Request for Additional Information No. 416, Supplement 6

U.S. EPR Standard Design Certification

Application Section: FSAR Chapter 6

Question 06.03-15:**Follow-up to RAI 212, Question 6.03-6**

Figure 06.03-15-1—Containment and IRWST Water Saturation Pressure for Hot Leg LOCA

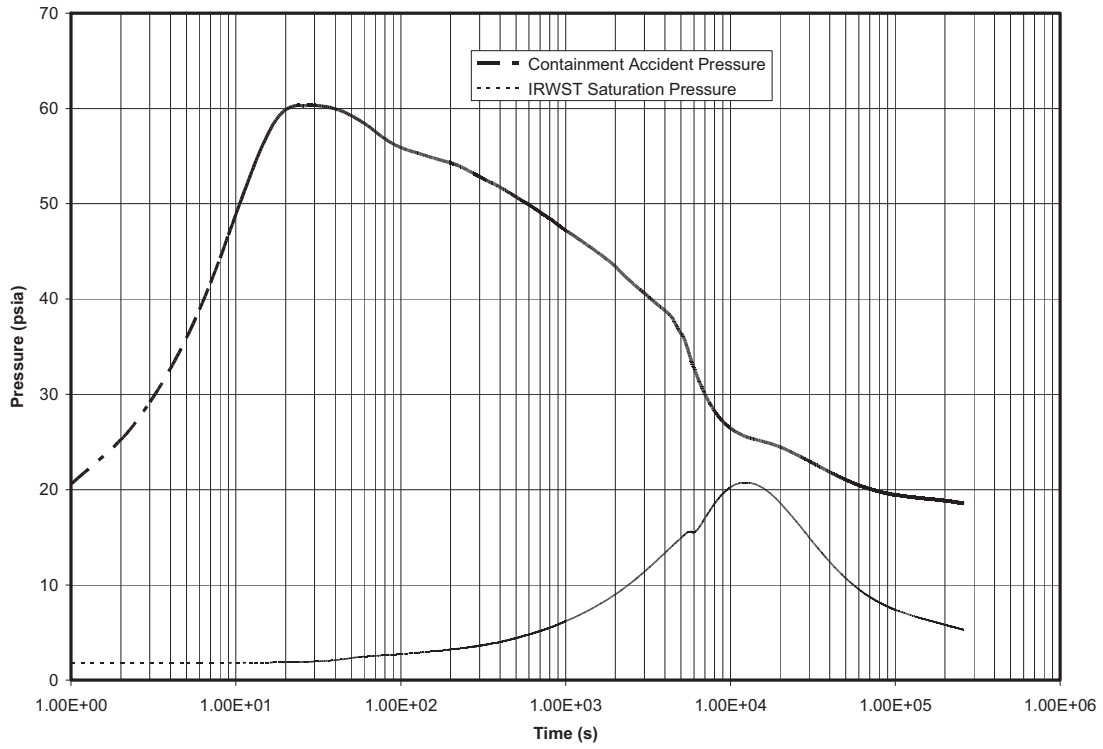
To conform to the referenced guidance it is necessary that the proper performance of emergency core cooling and containment heat removal systems be independent of calculated increases in containment pressure caused by postulated loss of coolant accidents.

The alternative approach described by AREVA (use of saturation pressure in NPSH analysis) is inconsistent with the US EPR DCD commitment to follow RG 1.1 and RG 1.82, Revision 3, and SRP 6.2.2 criteria (e.g., use of atmospheric pressure in NPSH analysis). AREVA's alternative approach did not address the basic premise behind the regulatory criteria and did not evaluate how their alternative to the SRP (RG) criteria provides an acceptable method of complying with NRC regulations. Additional information is needed to complete a safety finding that is clearly tied to 10CFR 50.46(b)(5). Therefore, NRC staff request that AREVA justify why the selected approach, use of containment accident pressure (CAP) to support ECCS NPSH analysis, is acceptable.

1. The likelihood of breaching the U.S. EPR containment structure under loss of coolant accident (LOCA) conditions was summarized with a particular emphasis on the pressure boundary integrity. Three breach mechanisms have been considered: rupture, leakage, and isolation failure and their impact on the U.S. EPR containment structure:
 - a) Rupture - The accident pressure resulting from the accident scenario (previously described) and plotted in Figure 06.03-15-1 shows a maximum pressure of ~ 65 psia

or 45 psig. This pressure is well below the 62 psig design pressure of the U.S.EPR design and consequently results in a negligible probability of containment rupture (much less than 10^{-8} at design pressure).

3. Figure 06.03-15-1 shows a comparison of the IRWST water saturation pressure versus time and the containment accident pressure (CAP) for a typical hot leg LBLOCA. As can be seen, the CAP is greater than the IRWST water saturation pressure for the entire transient. Because it has been demonstrated that NPSH margin exists for the entire range of IRWST temperature above 212°F, and that the minimum margin occurs at 212°F, it is immaterial whether the hot leg LOCA case presented in Figure 06.03-15-1 represents the most limiting IRWST water saturation pressure. In other words, should the most limiting IRWST water temperature be higher than the calculated 245°F, it will not adversely impact the conclusion with respect to NPSH margin. Likewise, it is immaterial whether the hot leg LOCA case presented in Figure 06.03-15-1 represents the most limiting lower bound containment accident pressure, because it is not used in the ECCS NPSH evaluation. Therefore, should the most limiting CAP be lower than that shown in Figure 06.03-15-1, it will have no impact on the conclusion with respect to NPSH margin.
